**ADDENDUM NO. 7**

**PROJECT NO. DGS C-0503-0027 PHASE 001**  
**PROJECT TITLE - Danville State Hospital - Replace Steam Generation Equipment**  
**PROFESSIONAL:**

ADMINISTRATIVE CHANGES – .1 GENERAL CONSTRUCTION AND .4 ELECTRICAL CONSTRUCTION CONTRACTS

DRAWN BY D. BOYER	DATE 10-14-2024	SHEET No. <b>E-4</b>
CHECKED BY T. BERTOLINO	SCALE As indicated

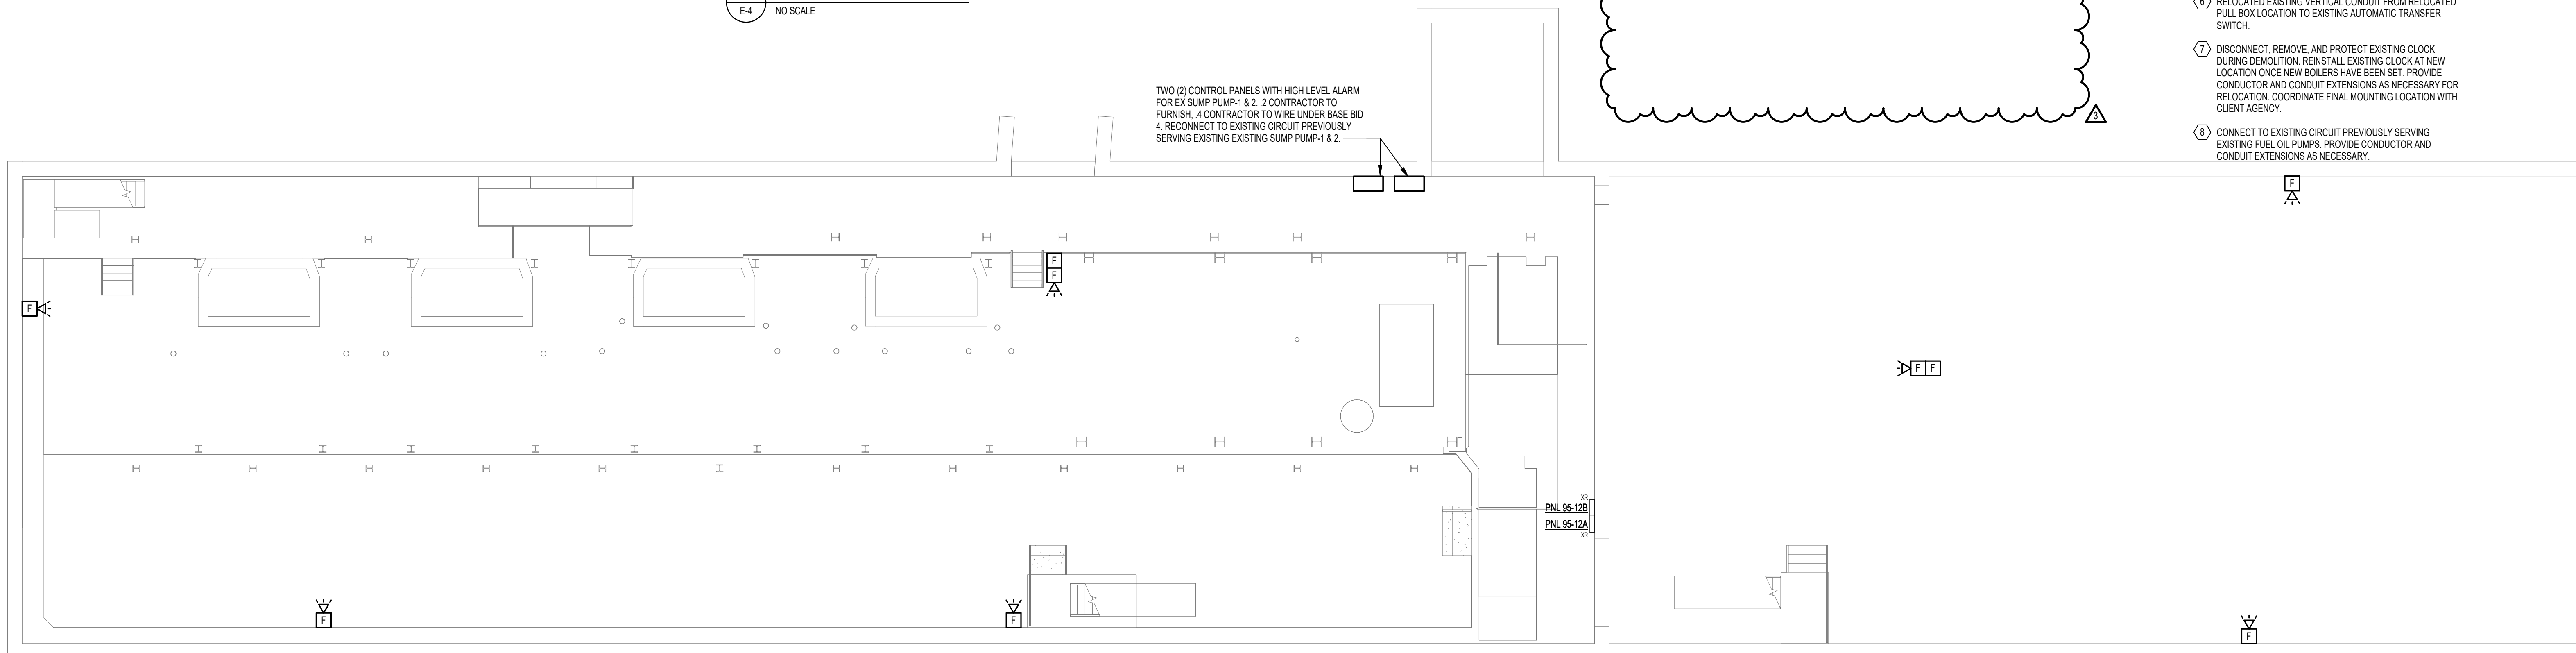
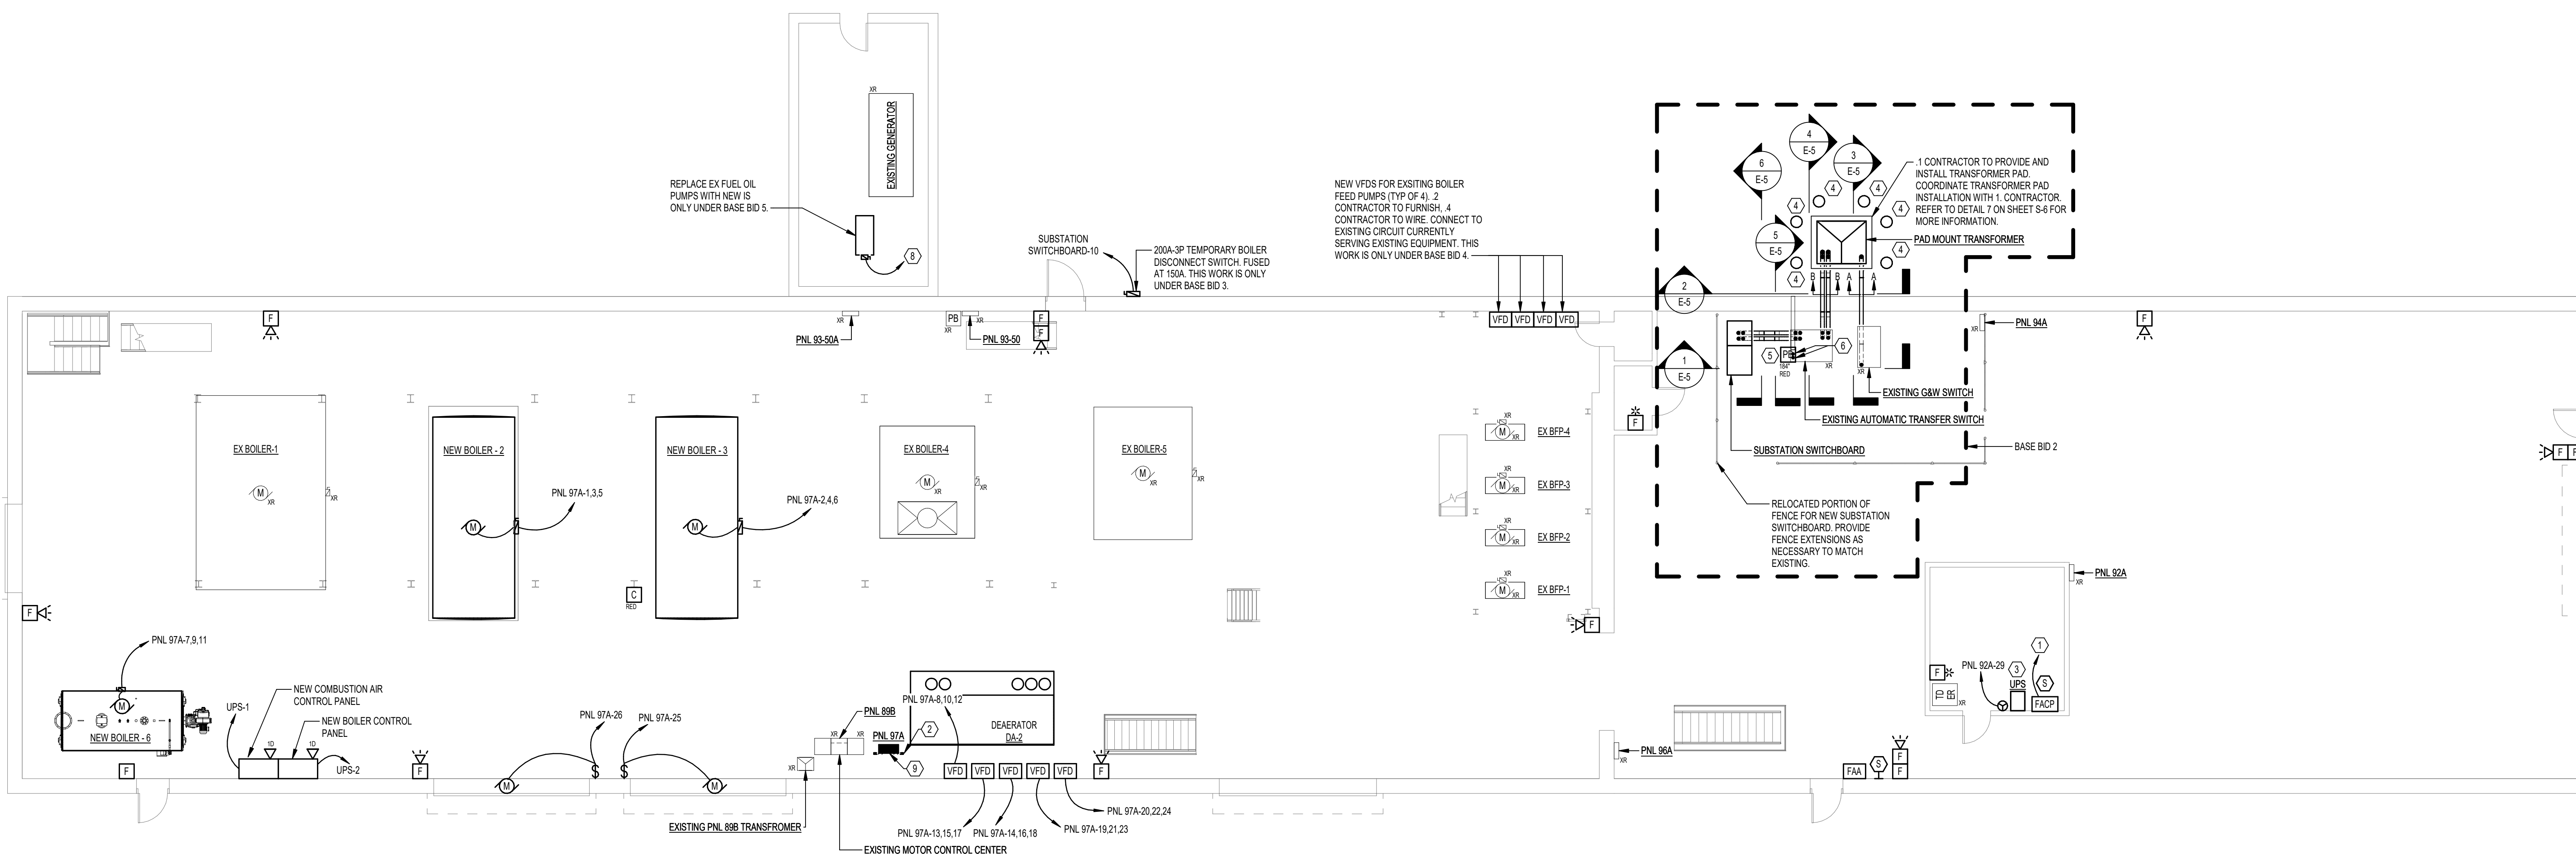
Item 1 - The .1 General Construction Contactor shall provide and install removable protective bollards shown on drawing E-4. Removable Concrete Bollard Detail has been added to drawing S-6. Drawing E-4 number note 4 has been revised to indicate the .1 contractor is to provide and install removable concrete bollards. Detail 5 on drawing E-4 has been removed. Drawing E-4 number note 3 has been revised to include UPS and battery pack for extended runtime specification requirements.

- 3 PROVIDE 3000VA UPS. PROVIDE RACK FOR MOUNTING OF UPS. UPS SHALL HAVE A MINIMUM RUN TIME OF 15 MINUTES. PROVIDE LS-8IP RECEPTACLE FOR INPUT CONNECTION TO UPS. PROVIDE (1) BATTERY PACK FOR EXTENDED RUNTIME (APC SRT3000). MANUFACTURER APC MODEL NUMBER: SRT3000XLAUS

- 4 PROTECTIVE BOLLARDS TO BE PROVIDED AND INSTALLED BY THE O.I. CONTRACTOR.
- 5 RELOCATED EXISTING PULL BOX. PROVIDE ALL NECESSARY MOUNTING HARDWARE.
- 6 RELOCATED EXISTING VERTICAL CONDUIT FROM RELOCATED PULL BOX LOCATION TO EXISTING AUTOMATIC TRANSFER SWITCH.
